Project	IEEE 802.16 Broadband Wireless Access Working Group < http://ieee802.org/16 >	
Title	Additional improvements for synchronous MBS transmission in MR	
Date Submitted	2007-07-05	
Source(s)	Keiichi Nakatsugawa Fujitsu Laboratories Ltd. Kamikodanaka 4-1-1, Kawasaki, 211-8588, Japan	Voice: +81-44-754-2811 Fax: +81-44-754-2786 nakatsugawa@jp.fujitsu.com
	Yuefeng Zhou Fujitsu Laboratories of Europe Ltd. Hayes Park Central Hayes Middx., UB4 8FE, UK	Voice: +44 (0) 20 8573 4444 FAX: +44 (0) 20 8606 4539 Yuefeng.zhou@uk.fujitsu.com
	Wei-Peng Chen Fujitsu Laboratories of America 1240 E. Arques Avenue, M/S 345, Sunnyvale, CA 95051, USA	Voice: +1 408-530-4622 wei-peng.chen@us.fujitsu.com
Re:	IEEE802.16j-07/019: "Call for Technical Comments Regarding IEEE Project 802.16j"	
Abstract	This contribution proposes some additional improvements for synchronous MBS transmission defined in the baseline document.

Additional improvements for synchronous MBS transmission in MR

Fig 1 MBS burst re-mapping from DL Relay Zone to DL Access Zone

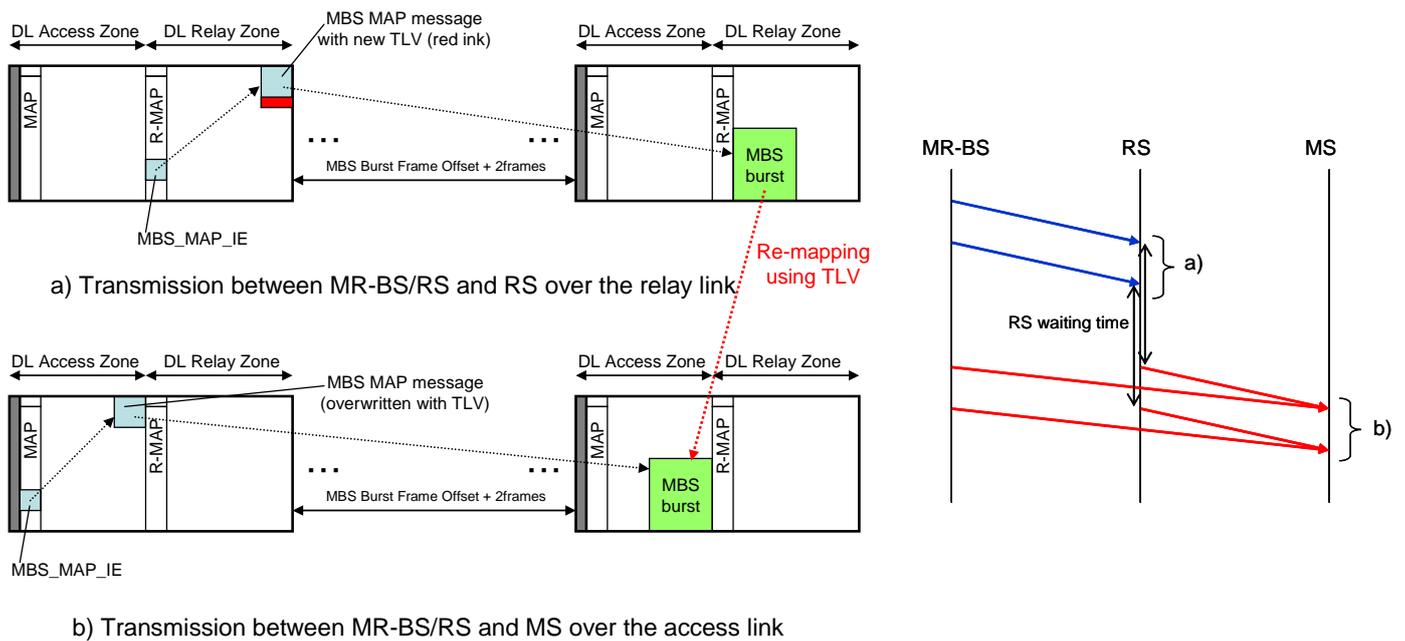
After the pre-transmission of MBS burst, the RS performs synchronized transmission of the MBS burst. At the time, the RS needs to perform re-mapping the MBS burst from the DL_Relay_Zone to the DL_Access_Zone. And, all the RS need to use same region and burst profile for the MBS burst in the DL_Access_Zone.

To achieve the re-mapping of MBS burst, a new TLV for MBS_MAP message needs to be defined. The TLV is only used for the pre-transmission between the MR-BS and the RS.

The TLV is used for each MBS_DATA_IE and/or Extended_MBS_DATA IE. The MBS_MAP message includes the same number of this TLV as the total number of MBS_DATA_IE and/or Extended_MBS_DATA IE. And the order of this TLV corresponds to the order of MBS_DATA_IE and/or Extended_MBS_DATA IE.

At the pre-transmission over the relay link, the MR-BS sets the mapping information (MBS DIUC, OFDMA Symbol Offset, Subchannel offset, Boosting, No. OFDMA Symbols, No. Subchannels, Repetition Coding Indication) indicating the MBS region in the DL_Relay_Zone in the MBS_DATA_IE and/or the Extended_MBS_DATA IE. When the RS received MBS_MAP message including this TLV, it receives the MBS burst from the MBS region in the DL_Relay_Zone of the frame which is transmitted after MBS Burst Frame Offset + 2 frames, then performs re-mapping the MBS burst in the DL_Access_Zone of the synchronized transmission frame according to the mapping information of this TLV. For the synchronized transmission over the access link, the RS overwrites the mapping information of MBS_DATA_IE and/or the Extended_MBS_DATA IE with this TLV and removes this TLV from the MBS_MAP message. Other information of the MBS_MAP message except the mapping information are reused for the synchronized transmission over the access link.

At the pre-transmission over the relay link, the MR-BS sets the mapping information (MBS DIUC, OFDMA Symbol Offset, Subchannel offset, Boosting, No. OFDMA Symbols, No. Subchannels, Repetition Coding Indication) in the MBS_DATA_IE and/or the Extended MBS_DATA_IE to indicate the MBS region in the DL_Relay_Zone. When the RS received MBS_MAP message including this TLV, it receives the MBS burst from the MBS region in the DL_Relay_Zone of the frame which is transmitted after MBS_Burst_Frame_Offset + 2 frames, then performs re-mapping the MBS burst in the DL_Access_Zone of the synchronized transmission frame according to the mapping information of this TLV. For the synchronized transmission over the access link, the RS overwrites the mapping information of MBS_DATA_IE and/or the Extended MBS_DATA_IE with values of this TLV and removes this TLV from the MBS_MAP message. Other information of the MBS_MAP message except the mapping information are reused for the synchronized transmission over the access link.

This TLV is included in the MBS_MAP message and transmitted from the MR-BS to the RS over the relay link in order to indicate mapping information for the MBS burst over the access link. This TLV is used and corresponded to each MBS_DATA_IE and/or Extended MBS_DATA IE. MBS_MAP message includes the same number of this TLV as the total number of MBS_DATA_IE and/or Extended MBS_DATA IE. And the order of this TLV corresponds to the order of MBS_DATA_IE and/or Extended MBS_DATA IE.

<u>Type</u>	<u>Length</u>	<u>Value</u>	<u>Scope</u>
<u>TBA</u>	<u>5</u>	<u>Bit #0-3: MBS DIUC</u> <u>Bit #4-11: OFDMA Symbol Offset</u> <u>Bit #12-17: Subchannel offset</u> <u>Bit #18-20: Boosting</u> <u>Bit #21-27: No. OFDMA Symbols</u> <u>Bit #28-33: No. Subchannels</u> <u>Bit #34-35: Repetition Coding Indication</u> <u>Bit #36-39: <i>Reserved</i></u> <u>Note: The definition of each value is same as MBS_DATA_IE and extended MBS_DATA IE.</u>	<u>MBS_MAP</u>
